CITY PLAN COMMISSION**THURSDAY, MAY 2, 2024****FILE NUMBER:** S234-082**SENIOR PLANNER:** Sharmila Shrestha**LOCATION:** Roseland Avenue at Peak Street, south corner**DATE FILED:** April 3, 2024**ZONING:** PD 298 (Subarea 1)**PD LINK:** [Article 298.pdf \(dallascityhall.com\)](https://dallascityhall.com/Article%20298.pdf)**CITY COUNCIL DISTRICT:** 2**SIZE OF REQUEST:** 0.213-acre**APPLICANT/OWNER:** Geoffrey Wattiker

REQUEST: An application to replat a 0.213-acre tract of land containing part of Lot 10 and all of Lot 10A in City Block 3/649 to create one lot on property located on Roseland Avenue at Peak Street, south corner.

PRELIMINARY PLAT

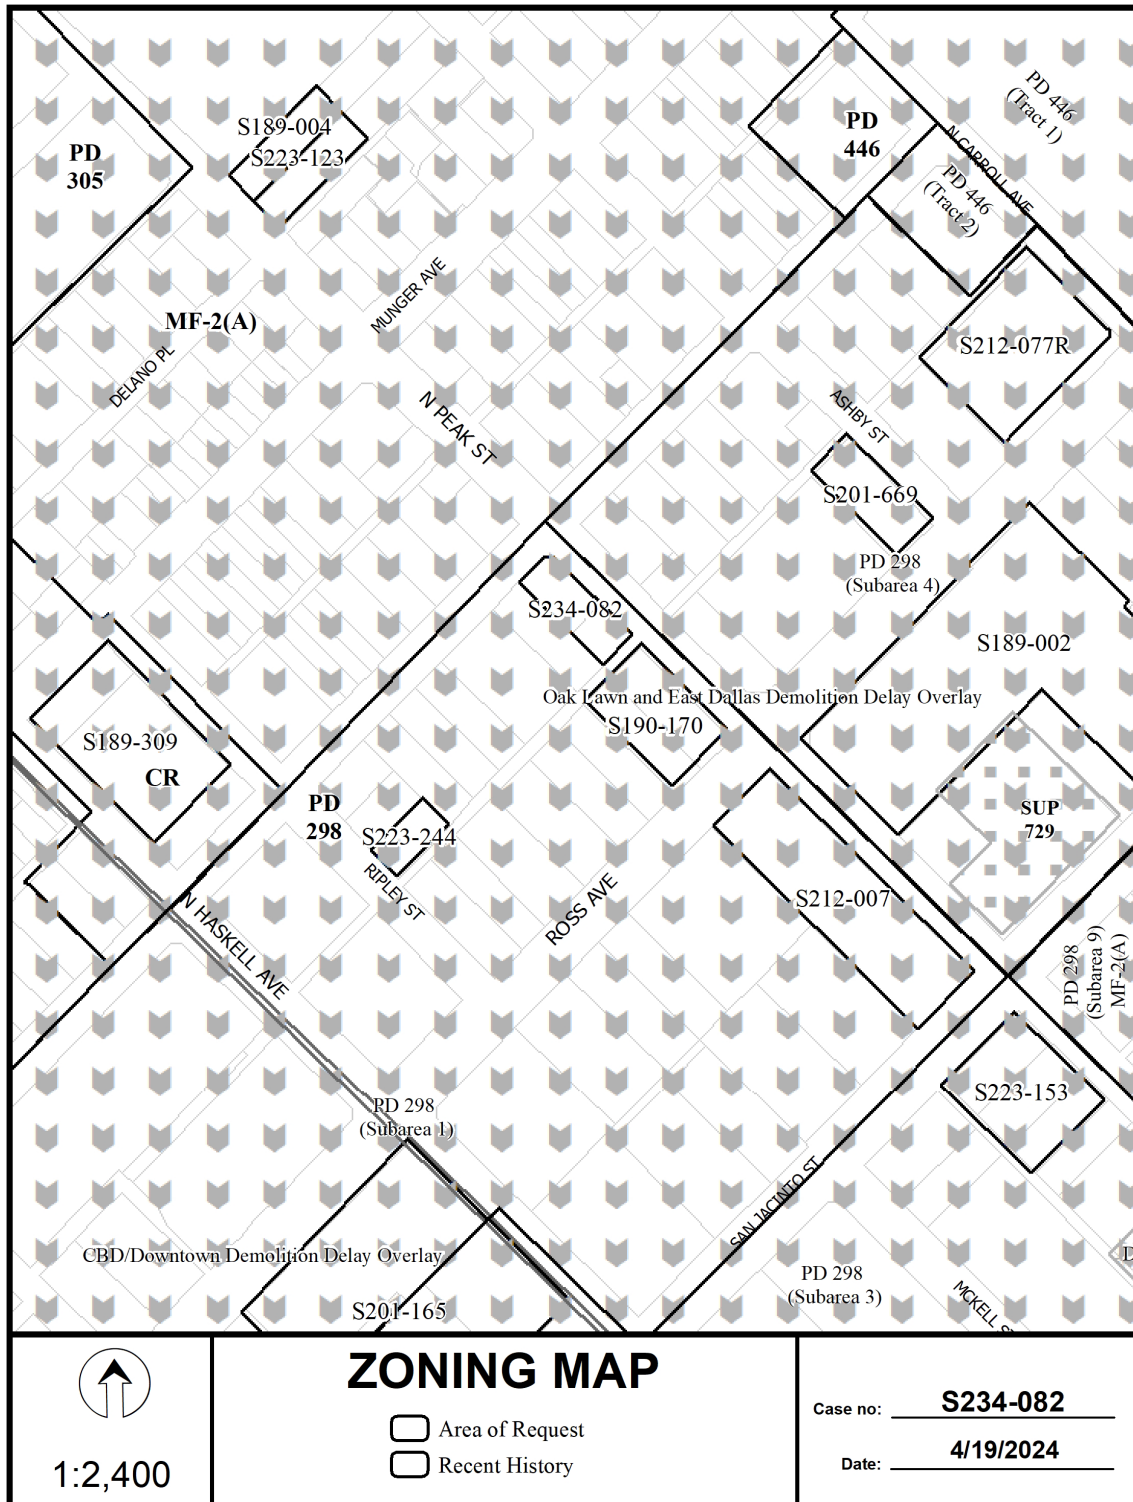
2. Department of Development Services, Engineering Division must verify that the plat conforms with the water, wastewater, and easement requirements under the provisions of Chapter 49 of the Dallas City Code.

5. Any new or existing structure may not extend across new property lines. *Section 51A-8.503(e)*
6. On the final plat, all easement abandonments, and ROW abandonments must be by separate instrument with the recording information shown on the face of the plat. A release from the Real Estate Division is required prior to the plat being submitted to the Chairman for signature.

7. On the final plat, include two boundary corners tagged with these coordinates: "Texas State Plane Coordinate System, North Central Zone, North American Datum of 1983 on Grid Coordinate values, No Scale and no Projection."

12. Submit a full set of Civil Engineering Plans (drainage, paving, street signage/markings/lighting) prepared per City Standards by a licensed (TX) Professional Engineer to Engineering Division in Room 200, Oak Cliff Municipal Center (i.e. 311T/DP). Additions and alterations to the public infrastructure require approval and may require private development contracts with bonds. 51A-8.102 (c); 8.601(b)(4),(5),(6),(7),(8),(9)
13. Detention may be required if the capacity of available outfall is not adequate to carry the developed runoff. Section 51A-8.611(c).
14. Place a note on the final plat stating "Lot-to-Lot drainage will not be allowed without proper City of Dallas Engineering Division approval" 51A 8.611(e)

15. On the final plat, dedicate 15-foot by 15-foot alley sight easement at Peak Street and Alley. Section 51A-8.602(e)
16. Comply with Mill Creek drainage requirements. Finish floor elevation must be 3' above nearest inlet, top of curb. 51A 8.611(d), C.9 of Mill Creek, Master Drainage Plan Study

17. Prior to final plat, submit a completed final plat checklist and all supporting documents.
18. On the final plat, show recording information on all existing easements within 150 feet of the property.
19. On the final plat, show all additions or tracts of land within 150 feet of the property with recording information.

20. Additional design information is required for assessment. Site plan must be submitted showing proposed development, building finished floor elevation, development, existing mains – including downstream manhole, and proposed water and wastewater service locations. Submit water/wastewater engineering plans to 320 E. Jefferson Blvd., Room 200, Attention: Water and Wastewater Engineering.
21. Engineer must furnish plans for water and sanitary sewer. Developer must furnish a contract for water and sanitary sewer. Sections 49-60(g)(1) and (2) and 49-62(b), (c), and (f).

22. Water and wastewater main improvements are required by Private Development Contract. Submit water/wastewater Engineering Plans to 320 E. Jefferson Blvd., Room 200, Attention: Water and Wastewater Engineering.

23. On the final plat, change “Rosss Avenue” to “Ross Avenue”.
24. On the final plat, change “FKA Flora Street Roseland Avenue” to “Roseland Avenue (FKA Flora Street)”.
25. On the final plat, identify the property as Lot 10B in City Block 3/649.
